Point-by-point Responses to Anonymous Referee #1 for #amt-2020-302 R3

Anonymous Referee #1

Table 1. Plausibility range for spike detection for each sensitive variable.

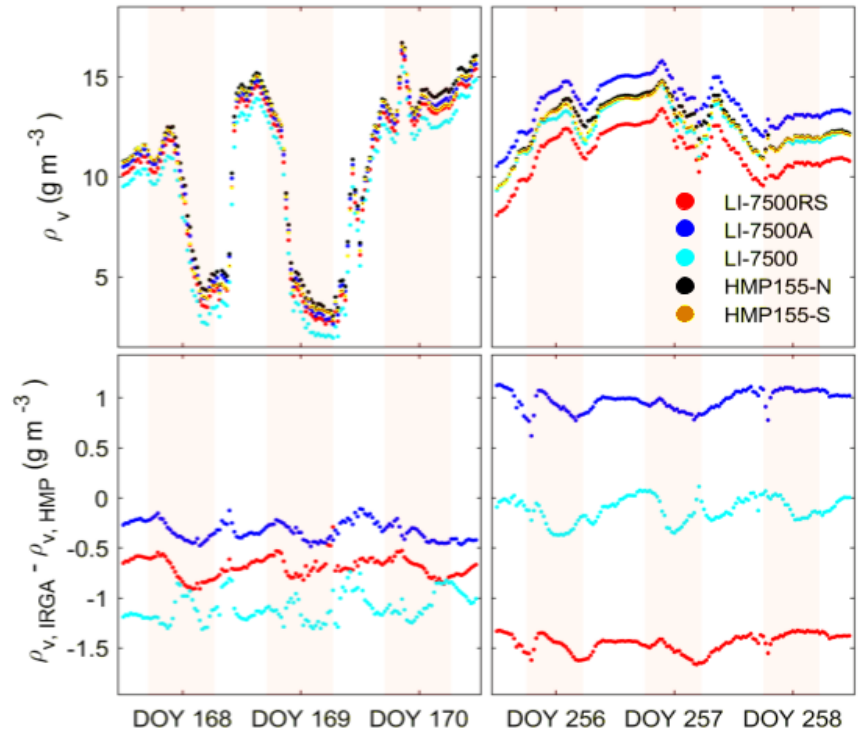
4. The reference to upper and lower values is still unclear (L186-8) and feels heuristic or arbitrary.

Response: Thank you for your insight. Please allow us to explain this range. They were determined by +/- 3.5 standard deviations in raw data for water vapor density. The 2 g H₂O m⁻³ (equals to 111 mmol H₂O m⁻³ or 2.7 mmol mol⁻¹) is the lower bound (-3.5 standard deviations) during the growing season at Bushland, Texas. The 30 g H₂O m⁻³ equivalent to 1,666 mmol m⁻³ or 42 mmol H₂O mol⁻¹ water vapor density as an upper bound (+3.5 standard deviations). In Eddy-Pro software, the despiking thresholds for both water vapor and CO₂ are +/- 3.5 standard

deviations of a moving window (usually a 5-minute window or 1/6 of flux averaging period with half window overlapped). See Table 1 below:

“Both upper and lower bounds were estimated by using ± 3.5 standard deviations of a 5-minute moving window with half window overlapped in water vapor density time series in Bushland, Texas.”

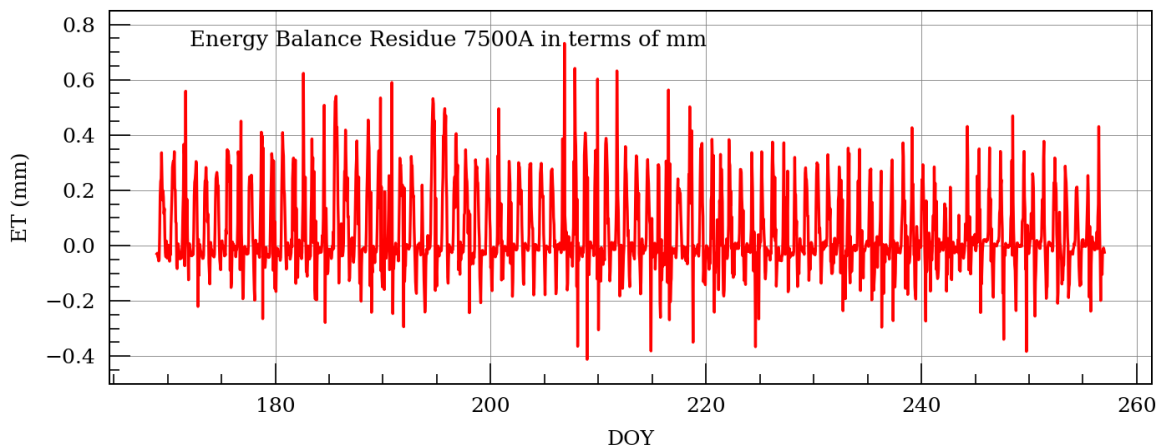
6. Fig 2 could be improved by increasing the marker size in the legend; the points there are too small for me to detect the difference in blues and greens. (particularly Li-7500 and HMP155S)

Response: Thanks for this good suggestion to improve readability. Legend marker size has been increased and the green is now dark orange to improve contrast. The updated figure is shown below:

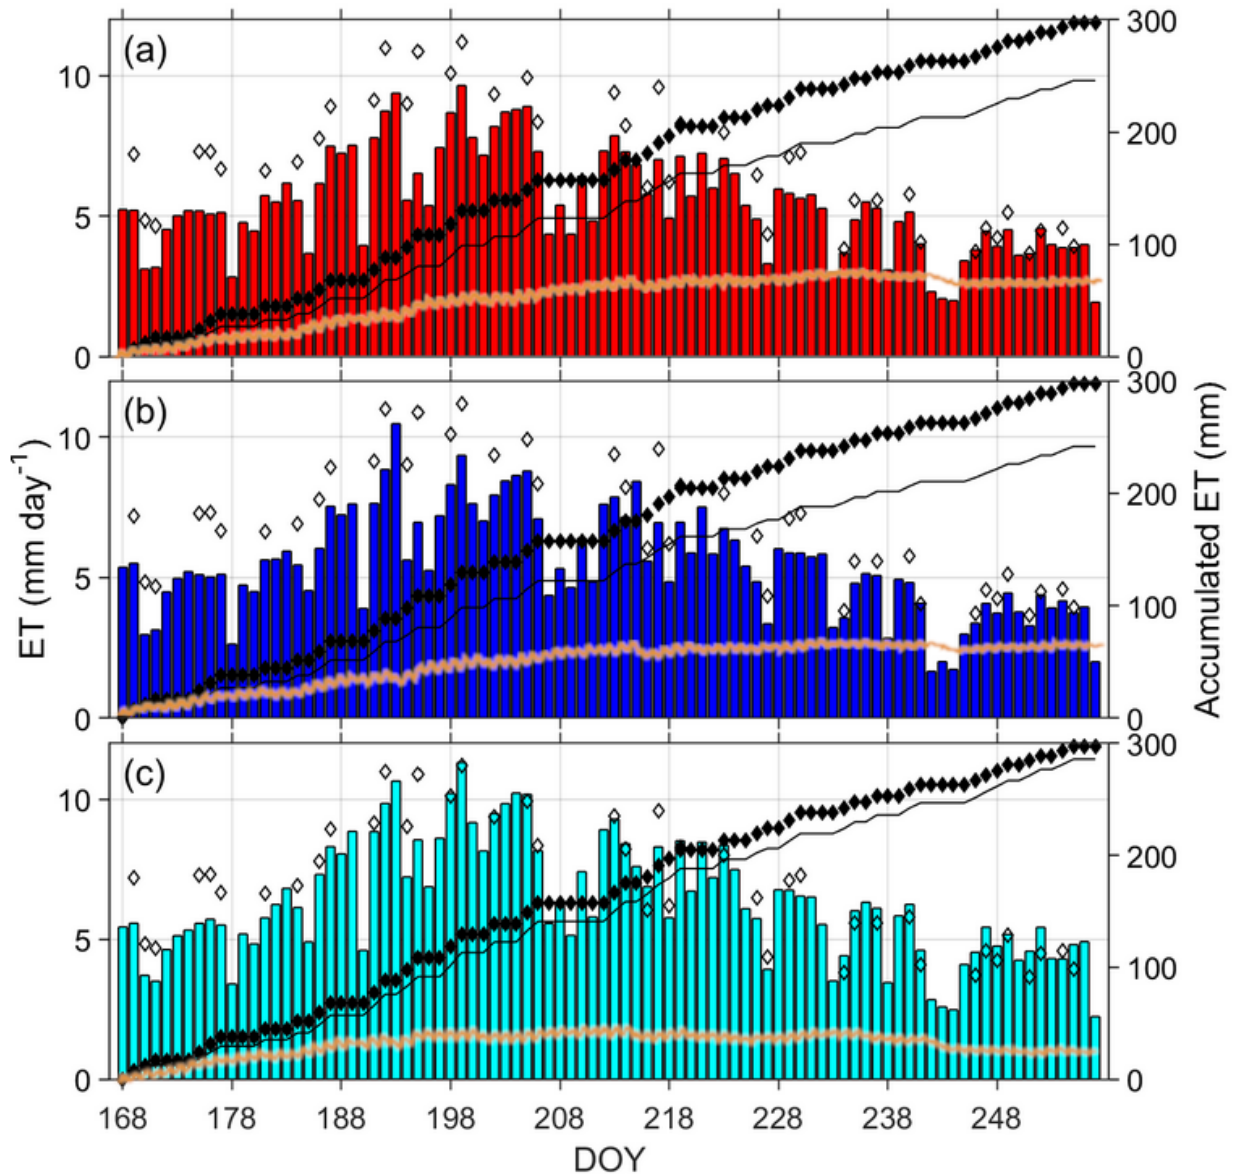
7. R1 MC2 the energy balance term discussion (L992-7) is not clear and could be still added to Fig 7. It won't confuse the reader to have additional, helpful information there. (see also the point made in response to R1MC3)

Response: We agree that additional information would be helpful to link the daily ET to the larger energy balance picture. Here is the energy balance residue from 7500A IRGA.

We added this energy balance residue term in Figure 7. The new Figure 7 is below,

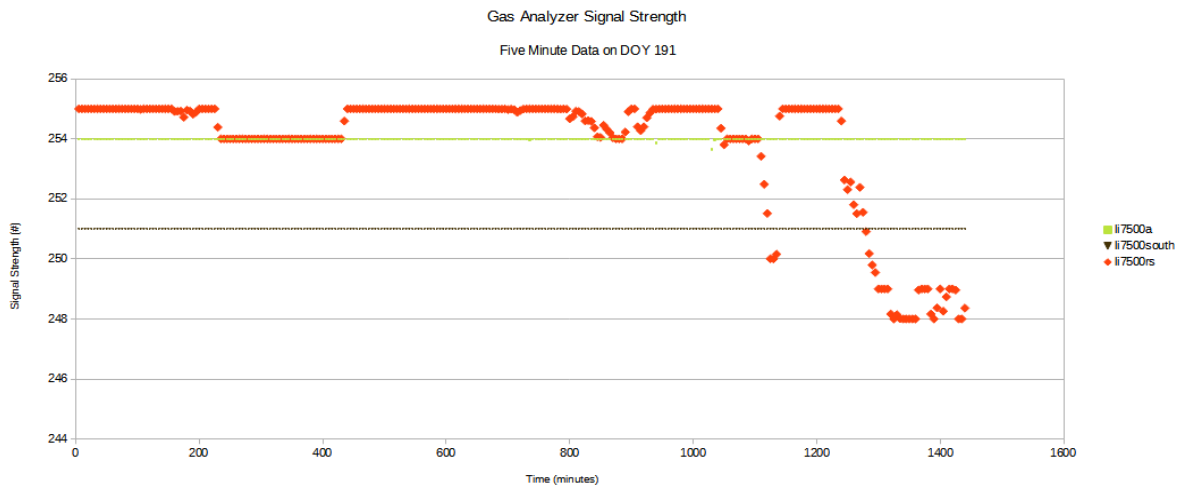
2. L309-310 did they see loss in signal strength (RSSI or ADC) during this period?

Response: RSSI is for 7700. All 7500 are ADC, in which the first 4 bits represent the signal strength. Yes, we did see loss in ADC for the LI-7500RS (see below).
